**THE UNITED STATES AIR FORCE
INSTALLATION RESTORATION PROGRAM**

INTERIM DECISION DOCUMENT

**PL001 AND SS086
EIELSON AIR FORCE BASE, ALASKA**

**FINAL
MARCH 2019**

PL001 MONITORING AREA PROPOSED LONG TERM MONITORING LOCATIONS		
EIELSON AIR FORCE BASE, ALASKA		
JACOBS	DATE: 11 JAN 2017	PROJECT MANAGER: K. MAHER
		FIGURE NO: A-2

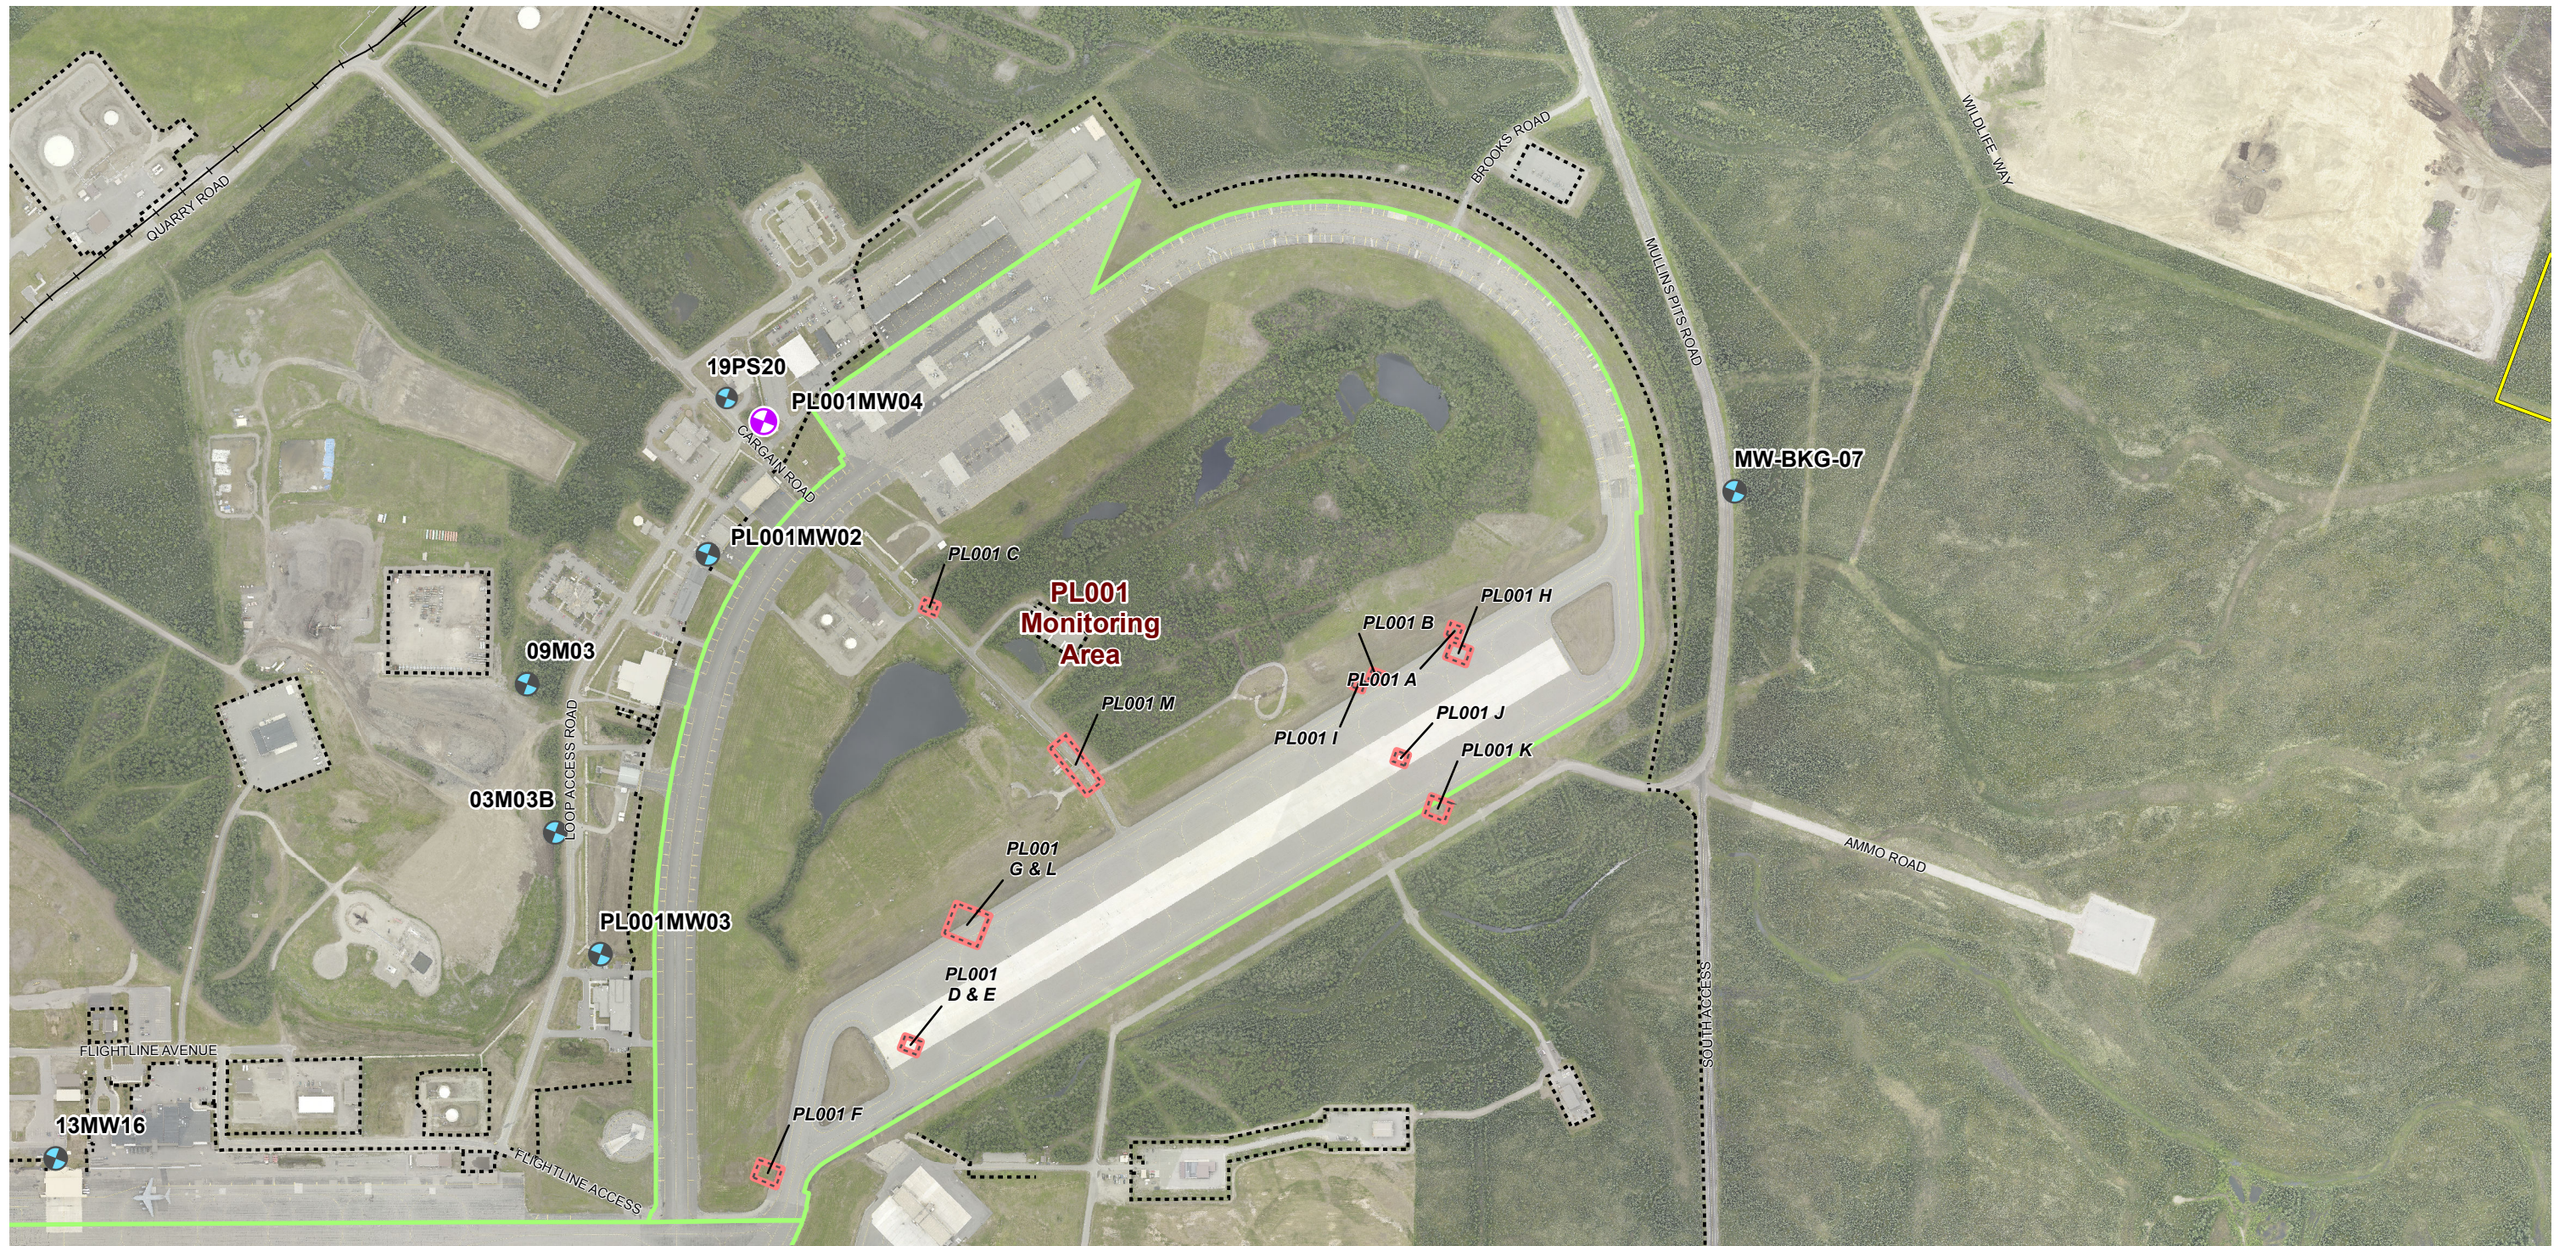
Comment No.	Page	Section	Comment / Recommendation	Response	DEC Accept/ Disagree
8.	2-2	2.1.2	The location information in this section should reference a map figure.	Accepted. A reference to Figure A-2 will be added to end of the second sentence of Section 2.1.2.	Accept

SS086 MONITORING AREA PROPOSED LONG TERM MONITORING LOCATIONS			
EIELSON AIR FORCE BASE, ALASKA			
JACOBS	DATE:	PROJECT MANAGER:	FIGURE NO.:
	31 JAN 2017	K. MAHER	A-3

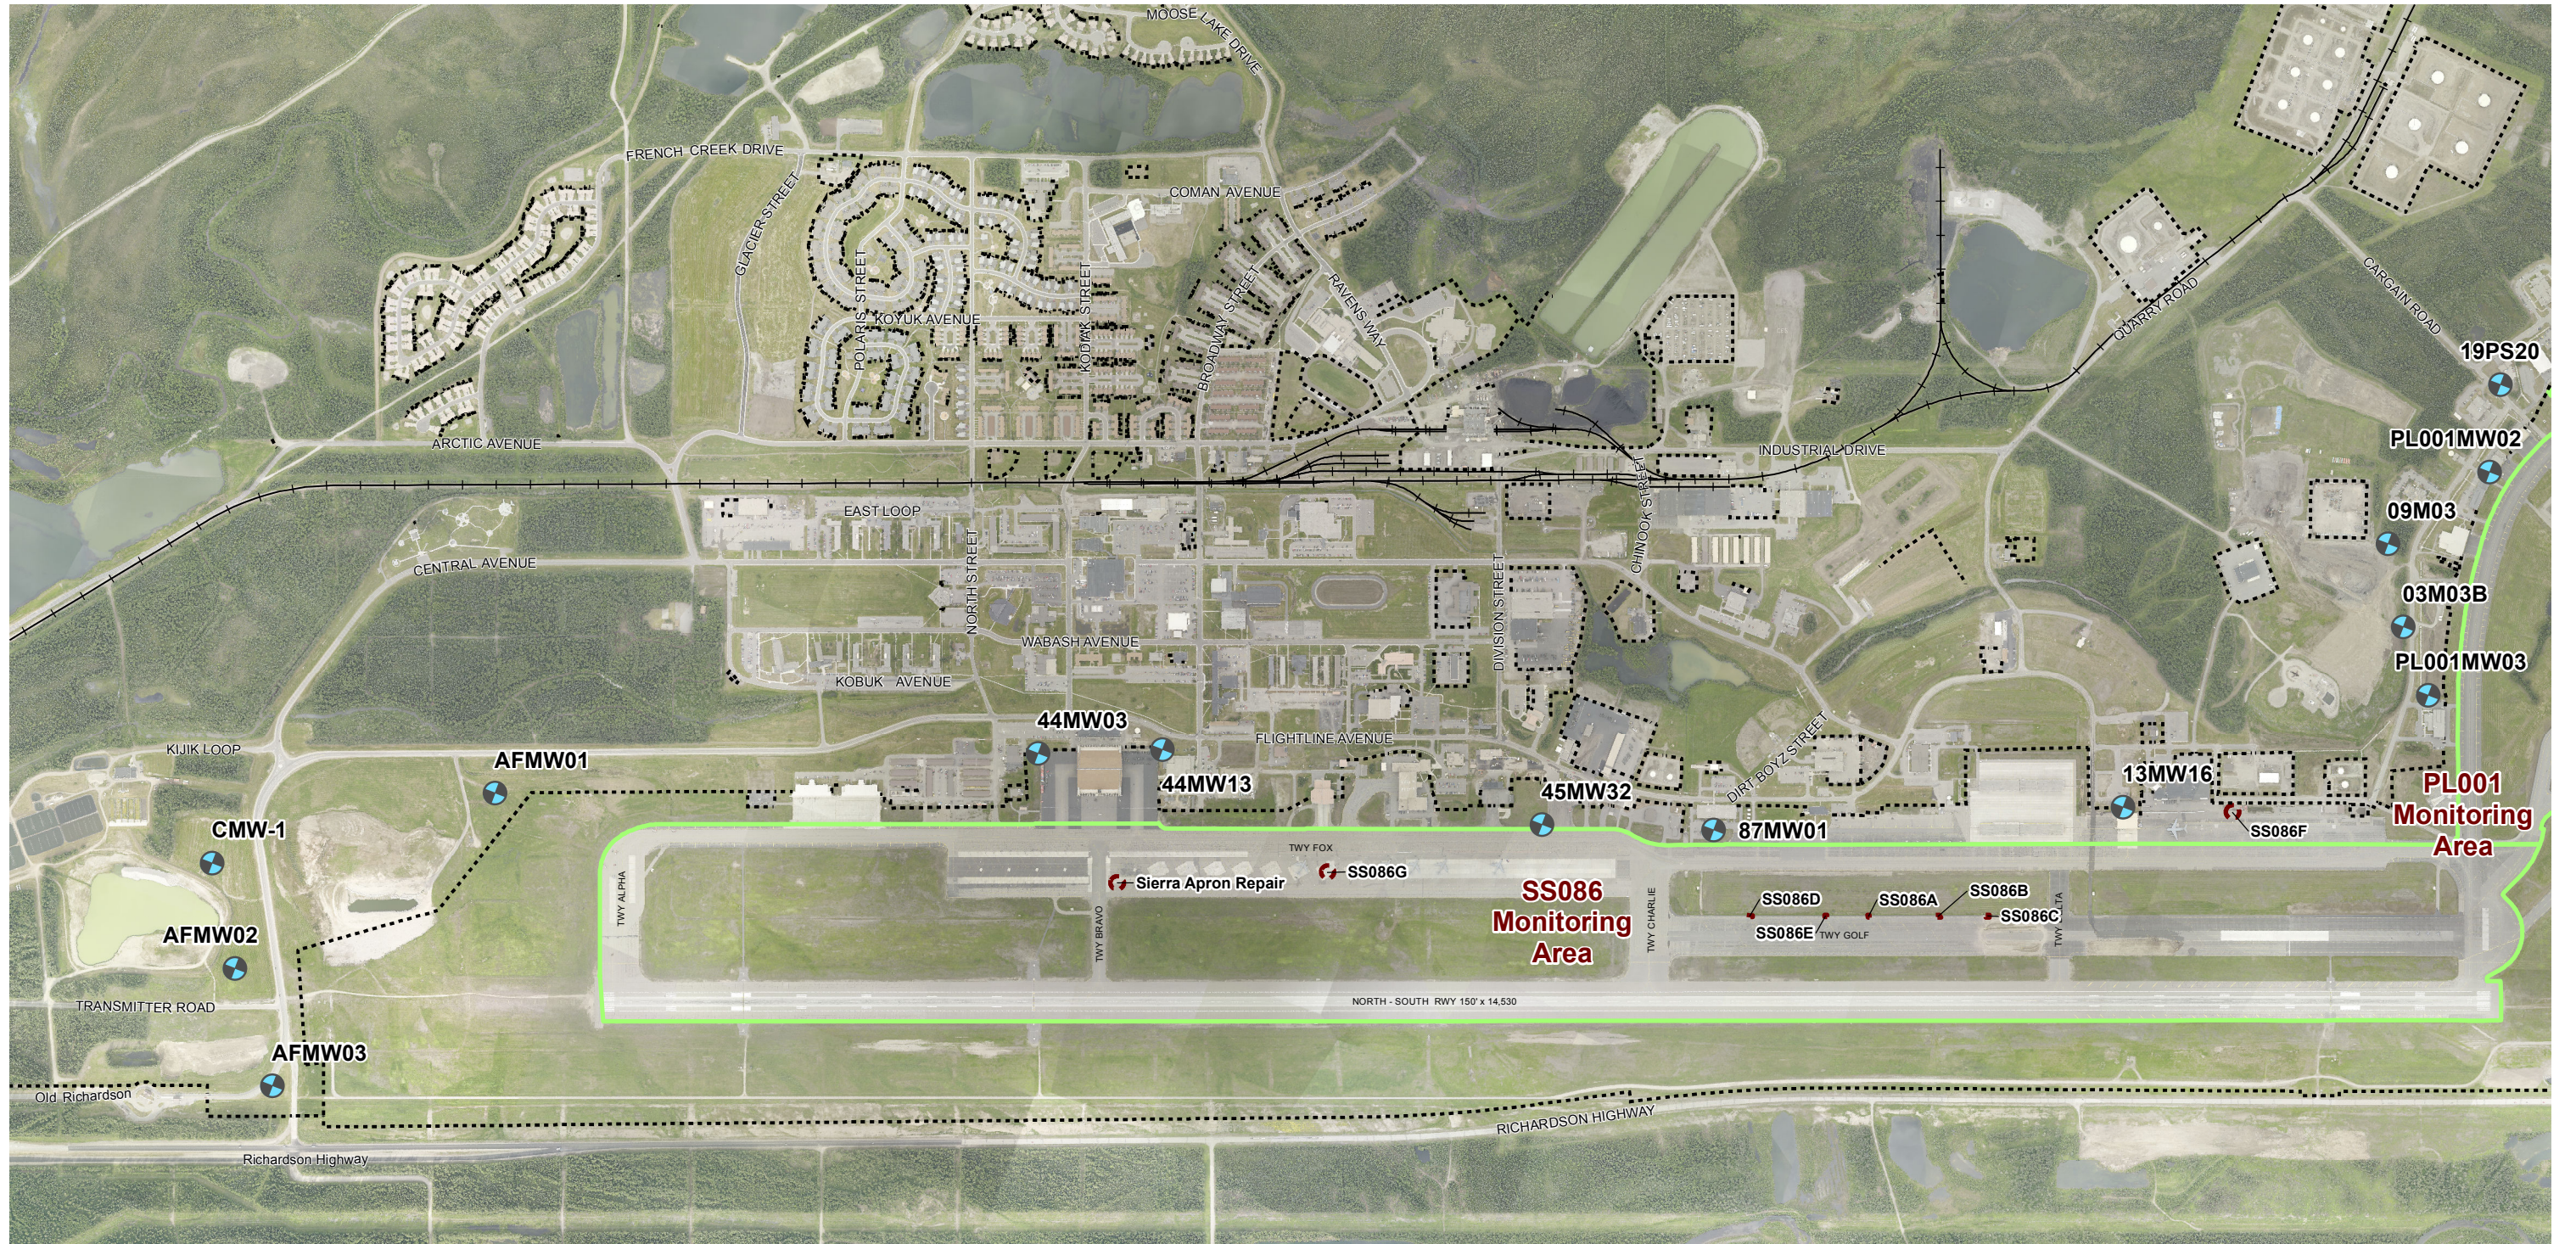
9.	2-3 to 2-7	2.1.3	The location information in this section should reference a map figure.	Accepted. Figure references will be added as follows: A reference to Figure A-3 will be added to end of the first, second, third, and fourth sentences of Section 2.1.3. A reference to Figure A-2 will be added to the first sentence of the first paragraph on page 2-3 A reference to Figure A-2 will be added to the first sentence of the second paragraph on page 2-4 A reference to Figure A-2 will be added to the first sentence of the second paragraph on page 2-5 A reference to Figure A-3 will be added to the end of the paragraph on page 2-6 A reference to Figure A-3 will be added to the first sentence of the second paragraph on page 2-7	Accept
